NOTICE OF ADDENDUM

ADDENDUM NO. 2

CITY OF MADISON
NAKOOSA TRAIL FLEET/FIRE/RADIO SHOP FACILITY

M-101E

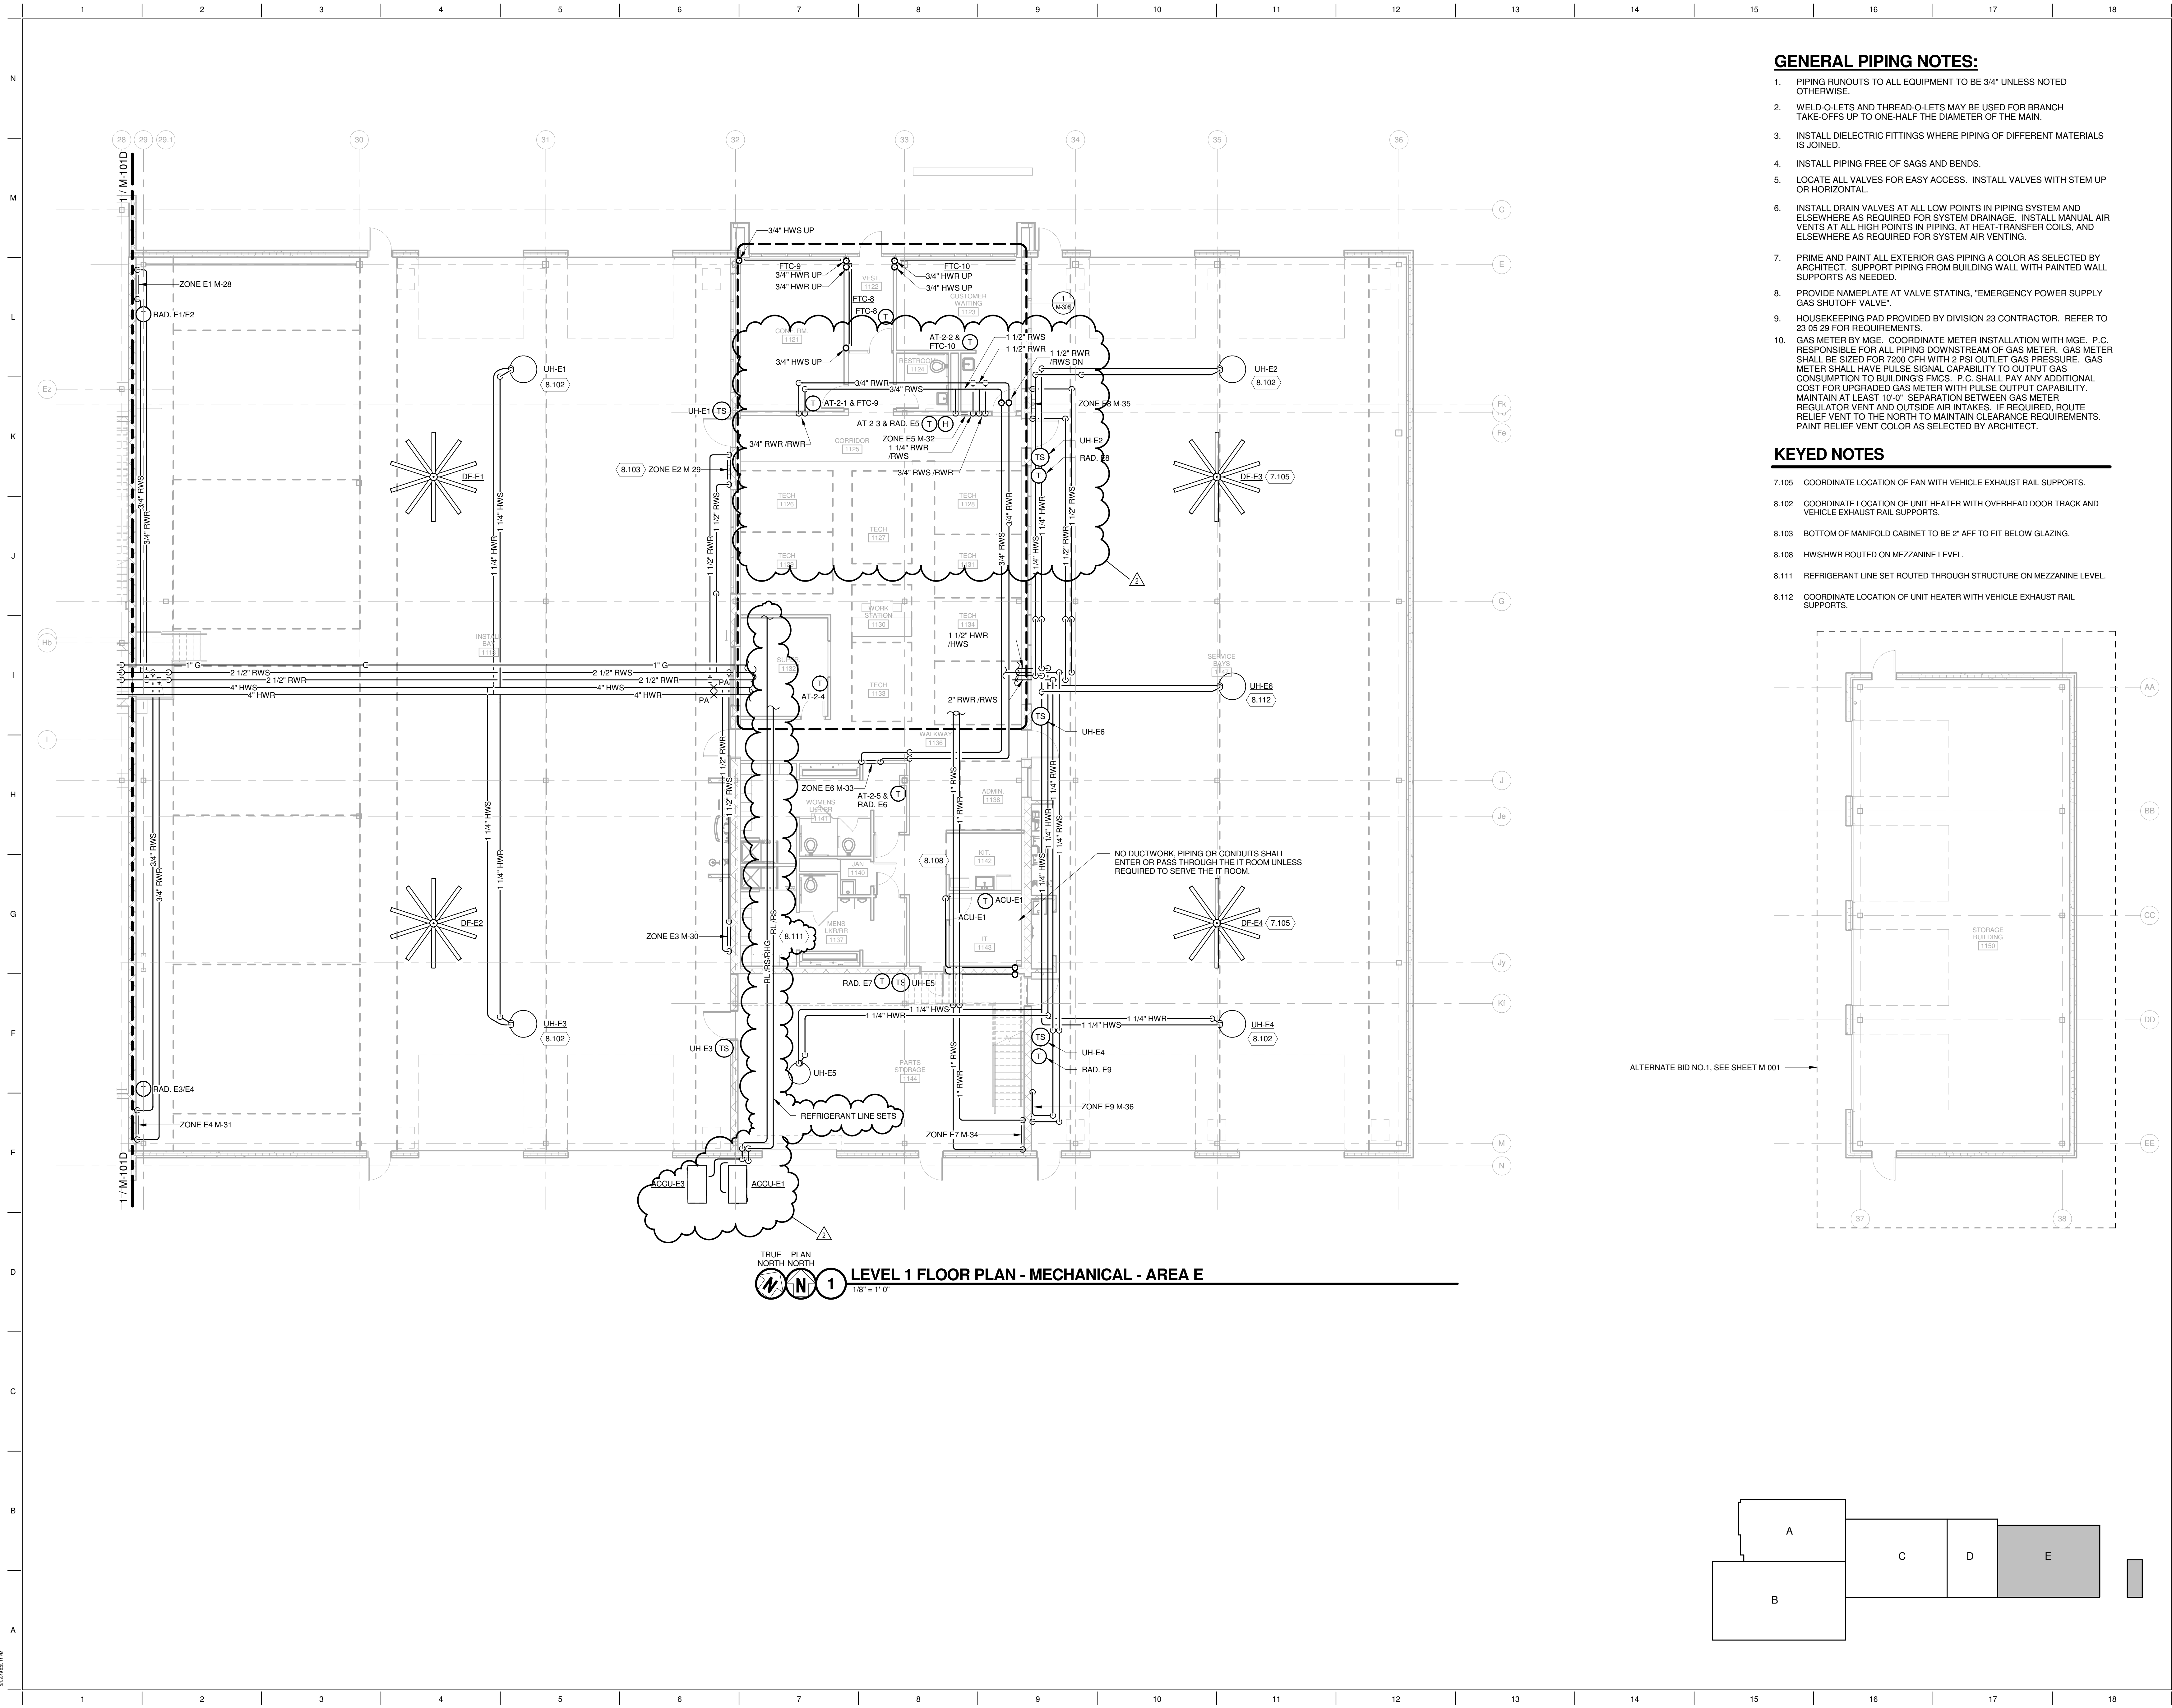
- JJJJ. **MODIFIED** M-101E LEVEL 1 FLOOR PLAN – HVAC – AREA E to revise ductwork air distribution for AHU-E1 as indicated on M-111E.
- KKKK. **MODIFIED** M-131E LEVEL 1 FLOOR PLAN – PIPING – AREA E to revise piping distribution as indicated on M-131E and added ACCU-E3 and refrigerant line set.
